ADMINISTRATIVE AMENDMENT

File # 07-10039 Project # 1001445

Added ponds, revised

HONG KONG CHINESE BUFFET
AMENDED TO SITE DEVELOPMENT PLAN
FOR BUILDING PERMIT

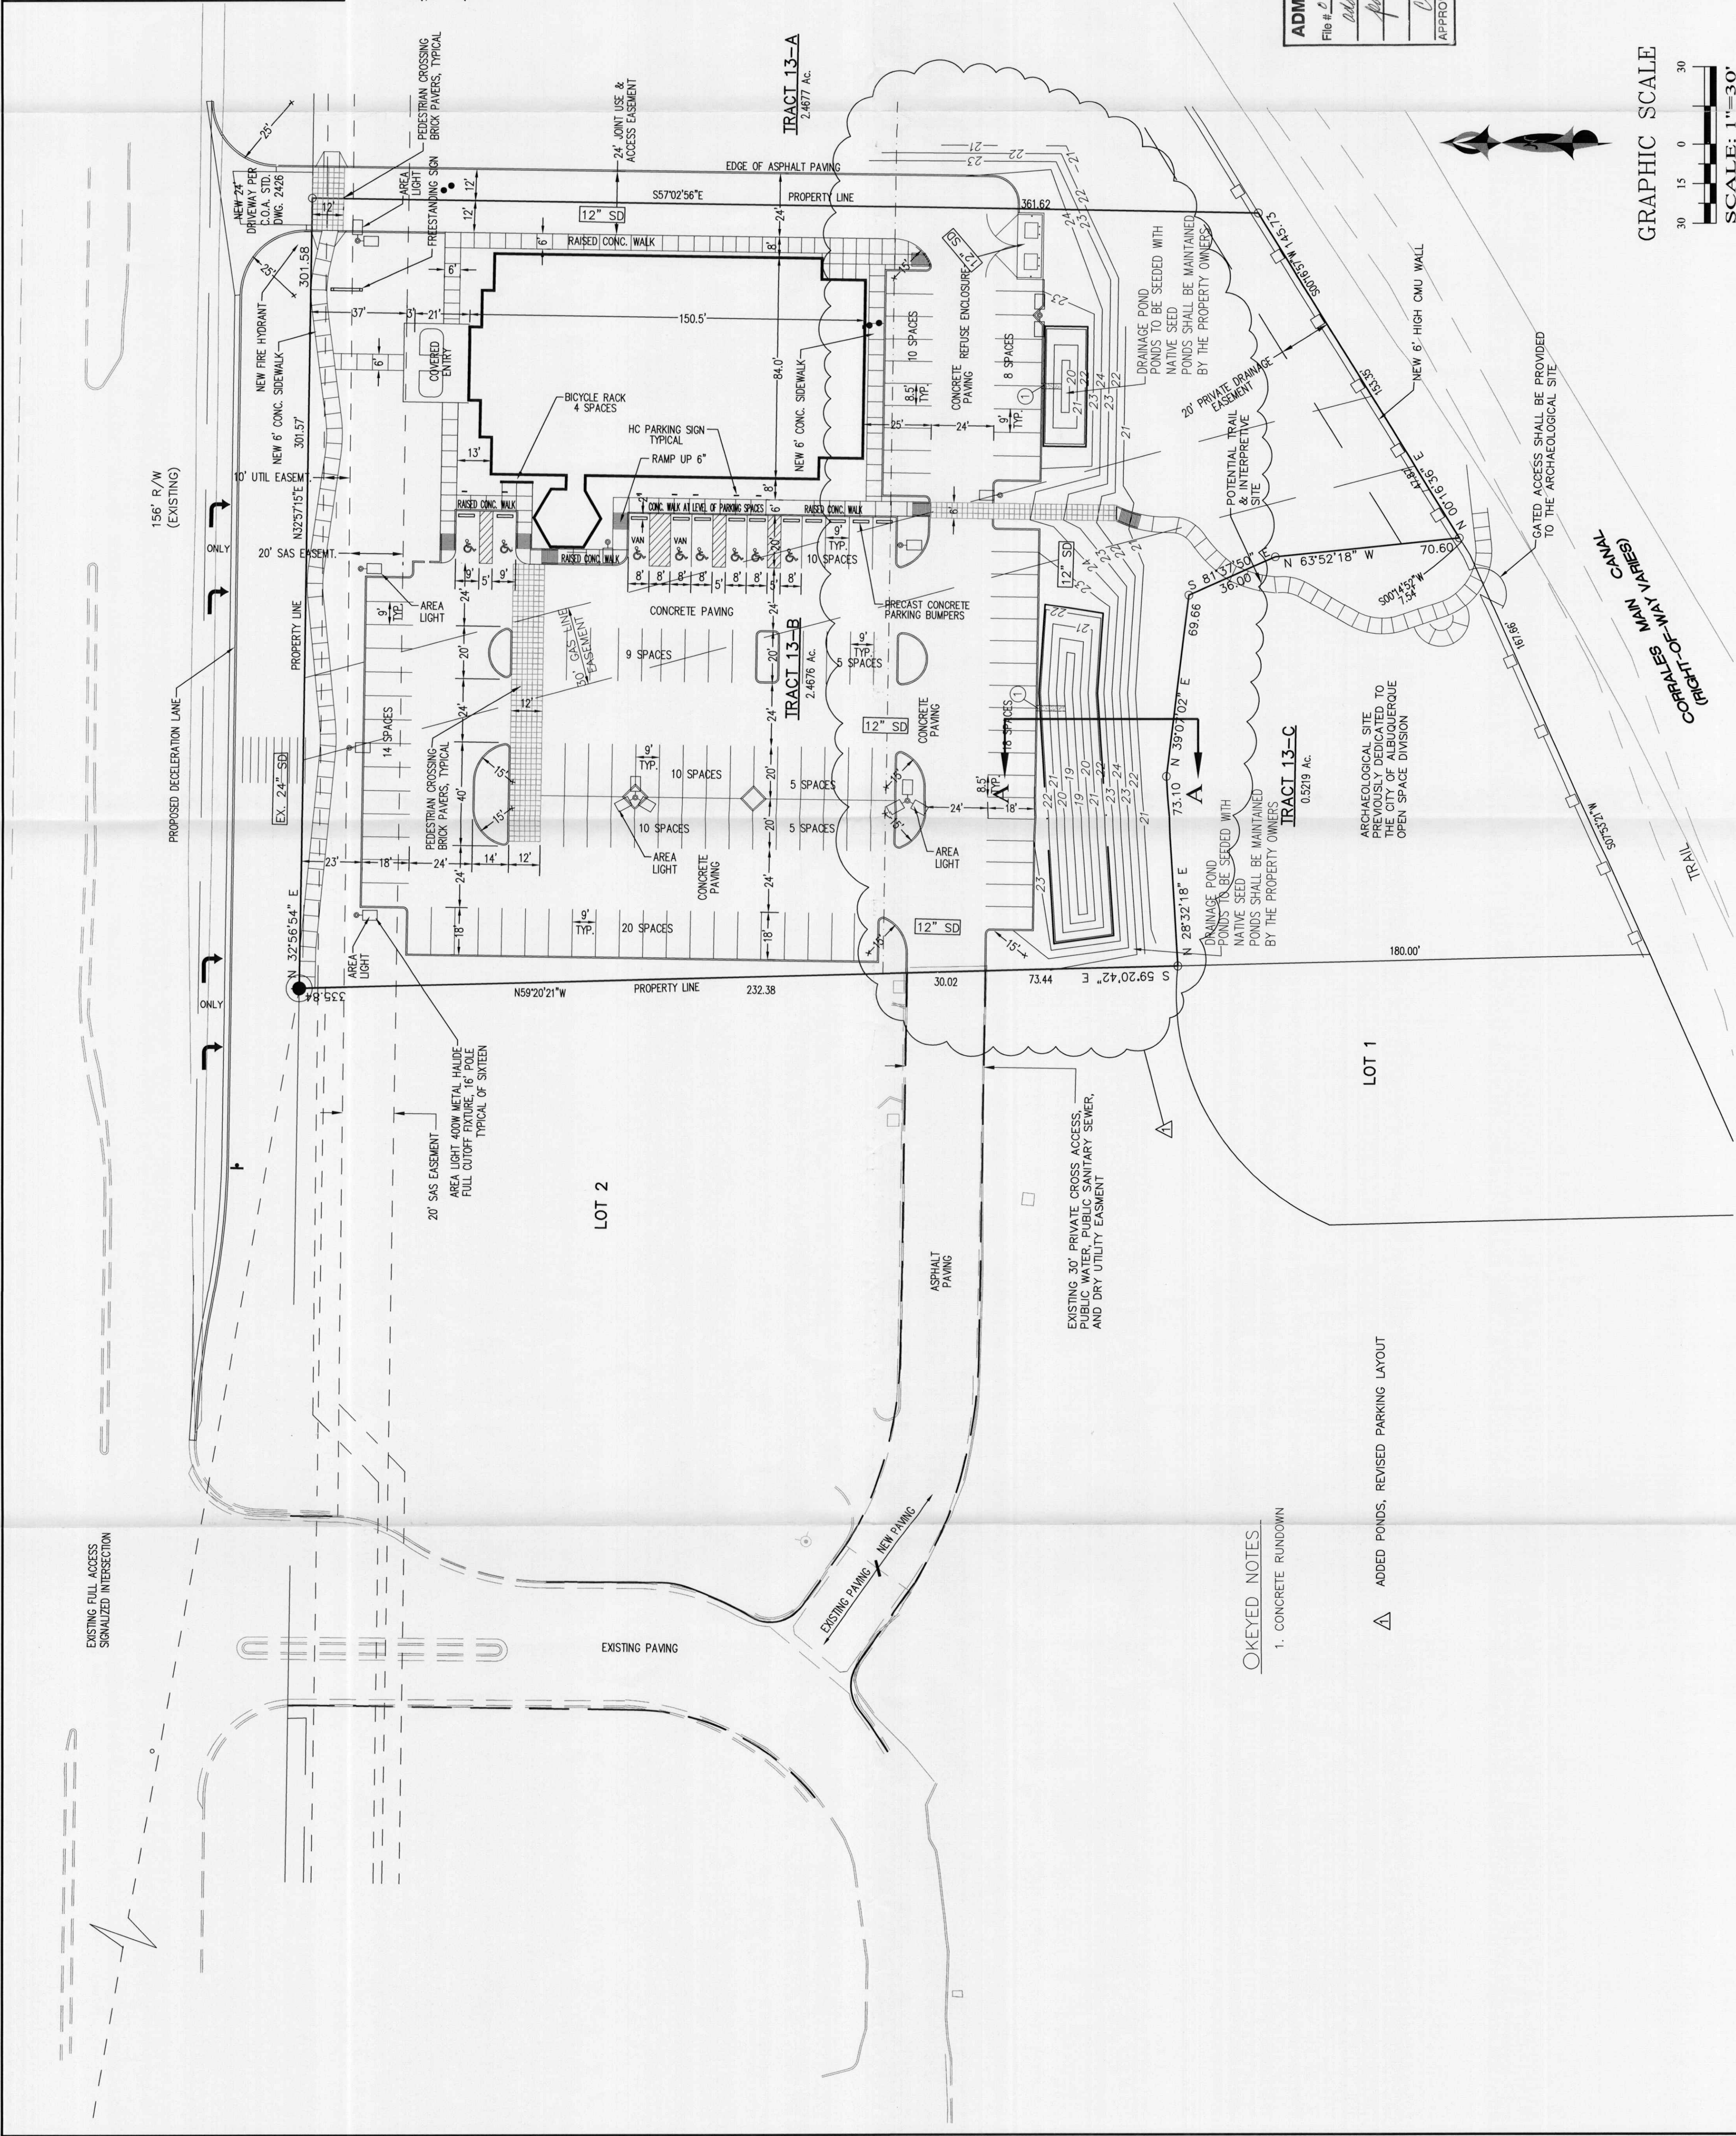
Paving lot layout

△ ADDED PONDS, REVISED PARKING LAYOUT

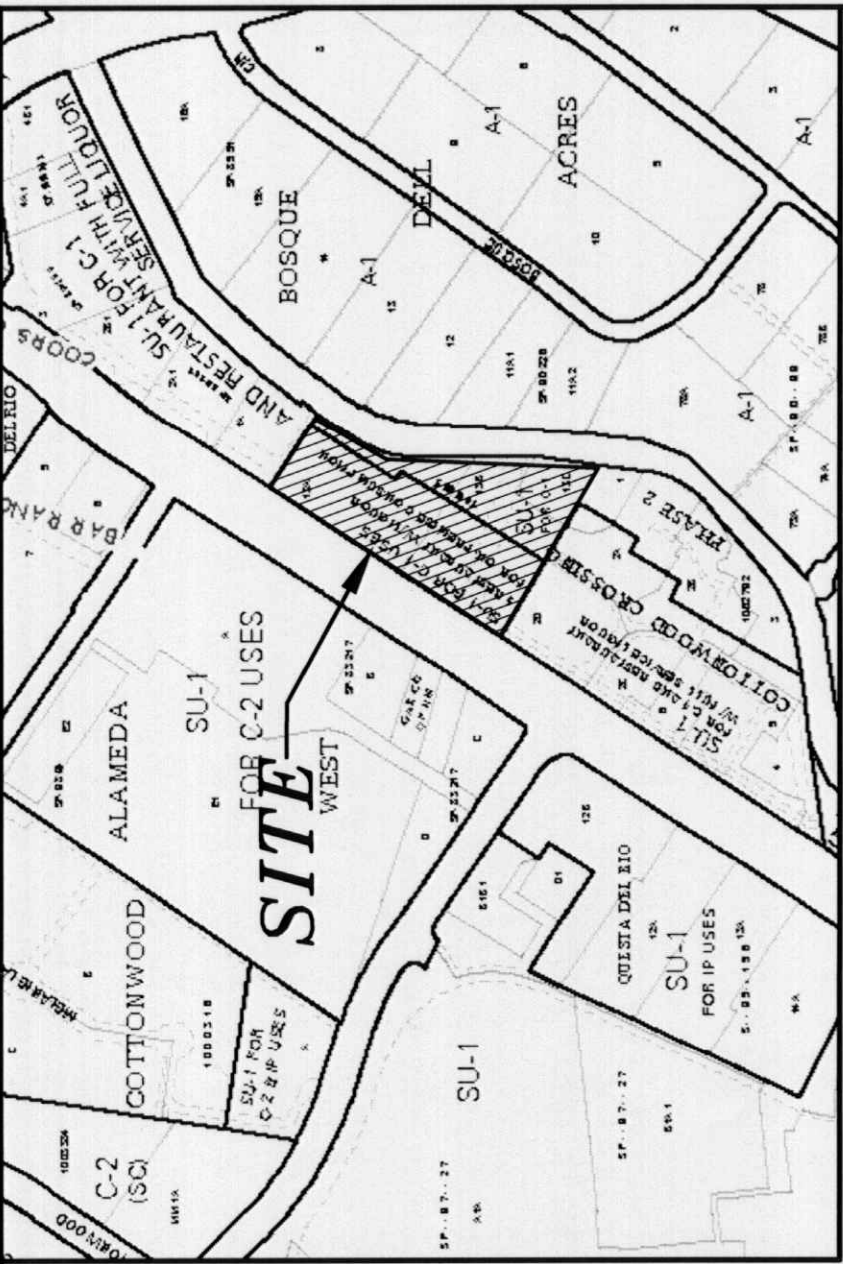
Added ponds, revised

parking lot layout
